MEMORANDUM

To: Montgomery Township Zoning Board of Adjustment

Re: **The Malvern School Properties, LP**
Height Variance, Preliminary Site Plan and Bulk Variances
Variance Review 2
982 Georgetown-Franklin Turnpike
Block 28010, Lots 57 & 58
H-C Highway Commercial Zone

Date: May 17, 2023, Amended May 23rd

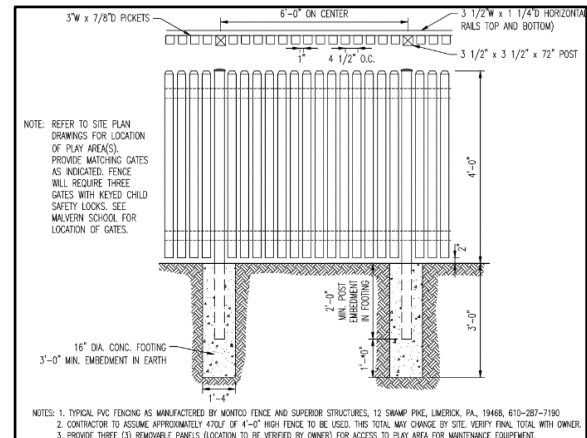
5.1. **Childcare Center Fence:** The plan indicates a fence around the childcare center. Per the detail provided (shown to the right), the fence is a vinyl board-on-board fence with child safety locks. No fence color is indicated.

5.2. **Childcare Center Fence Height:**

Per §16-5.3b, fences shall not be erected that are higher than four (4) feet. The childcare center fence, which wraps around the two (2) sides and rear of the building, is four (4) feet in height. The plan complies.

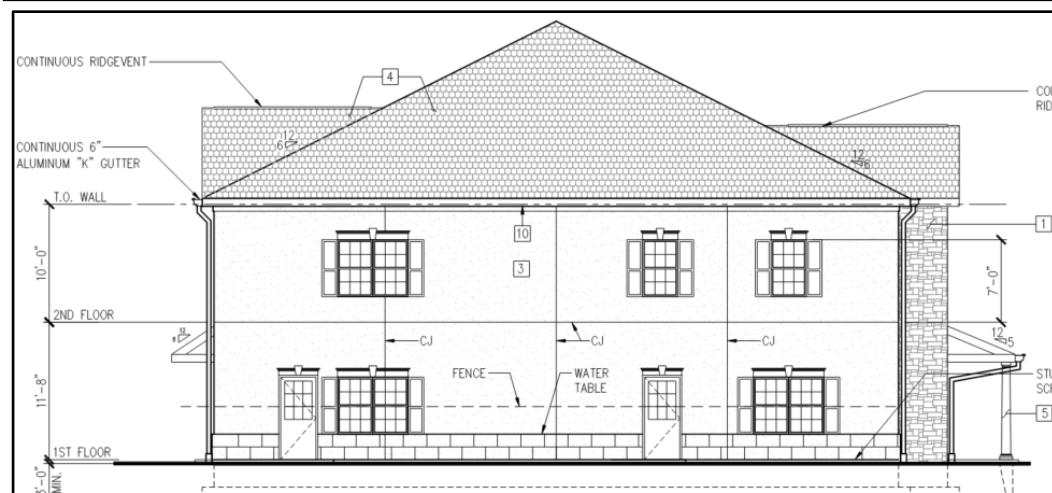
10.8. Visual Breaks: *Variance relief is required.* §16-4.12e.5(a) requires that building exteriors shall have vertical and/or horizontal offsets to create visual breaks along each facade. Long, monotonous, uninterrupted walls are not permitted. While the front and rear façade of the building contain visual breaks, the sides, as indicated in the image above, do not. **Variance relief is required.**
